1986 - 1987 Corvette: Service Bulletin: Convertible Top Number 5 Bow Weatherstrip Loose

Subject: Convertible Top Number 5 Bow Weatherstrip Loose

Bulletin Number: 87-148, Number 10

NUMBER 5 BOW WEATHERSTRIP

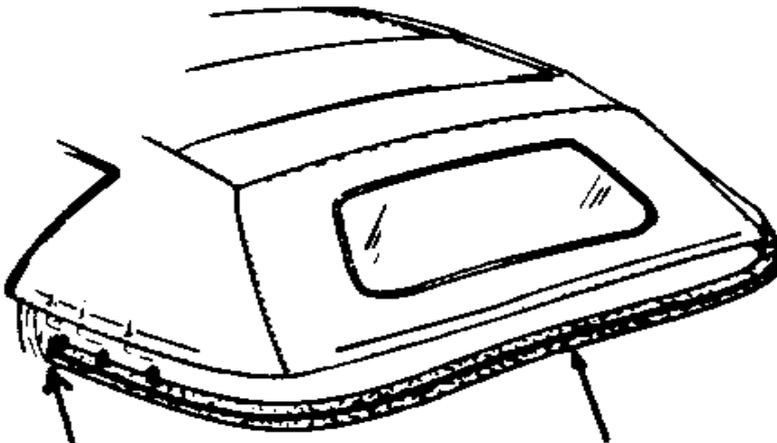
Comments have been reported that on some Corvette convertibles, the number 5 bow weatherstrip pulls loose from the bow at the front ends. Effective with start of 1987 production, the source used an adhesive which eliminated this problem on 1987 vehicles.

FRONT ENDS OF WEATHERSTRIP
PULL LOOSE AND FOLD BACK.
MAKE SURE ADHESIVE IS APPLIED
ALL THE WAY TO THE FRONT END OF WEATHERSTRIP.

Field repairs can be accomplished by gluing the weatherstrip ends down with 3M weatherstrip adhesive, P/N 08011, or P/N 12345096-7 weatherstrip adhesive. (See illustration). Before applying adhesive wipe the weatherstrip with alcohol or all purpose adhesive cleaner to remove any mold release compound. Care should be taken to make sure the adhesive is applied all the way to the extreme forward ends of the weatherstrip. Also, be sure the plastic nails are installed properly. If the weatherstrip is damaged, it will have to be replaced.
